RE: SEQRA
Review of Additional Visual Impact Analysis
CPV Valley Energy Center
Town of Wawayanda
Orange County, New York

My office has conducted a review of the technical memorandum *Additional Visual Impact Analysis Aboveground Electric Transmission Line* for the CPV Valley Energy Center dated February 4, 2010. This review focuses on substantive issues regarding the incremental environmental impacts of the transmission poles and wires that are the subject of this additional study.

Figure 7: Transmission right of way and pole location show with wetlands

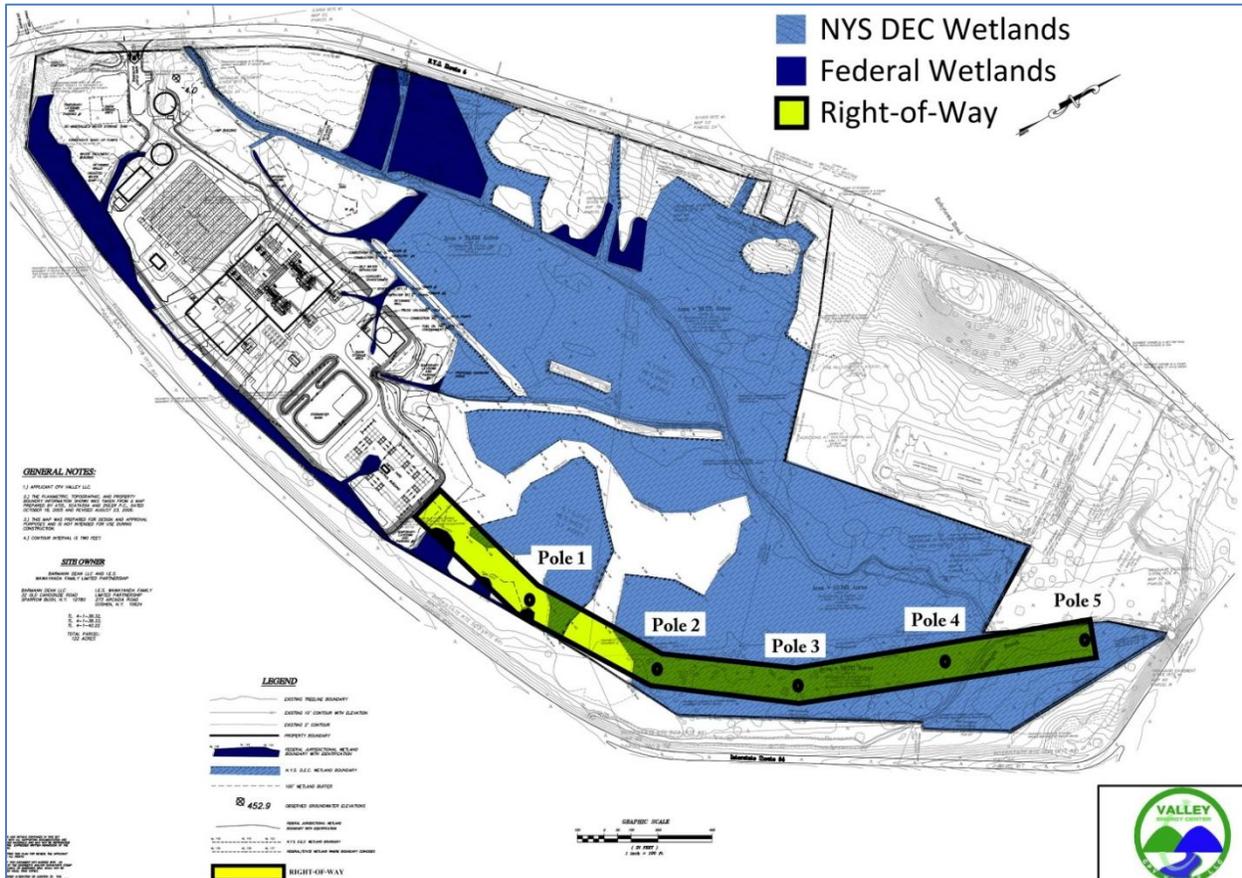
The largest wetland starts in-between poles 1 and 2 and continues to the riser pole (pole 5) near NYS Route 17. Smaller wet areas exist between the facility and pole 2. The January 27th Planning Board discussion incorrectly identified the area around poles 3, 4 and 5 as not being in wetlands and the discussion focused on burying the wires strung from the poles with the largest impact (3, 4, and 5) and not 1 and 2 because of wetland concerns under poles 1 and 2. The following image shows wet areas in blue on the simulation from the I-84 entrance ramp.

Virtually all of the open area visible between the entrance ramp and Horizons are wetlands; if the poles with the largest impact (3, 4 and 5) from this viewpoint are removed, the wires will be buried entirely through wetlands.
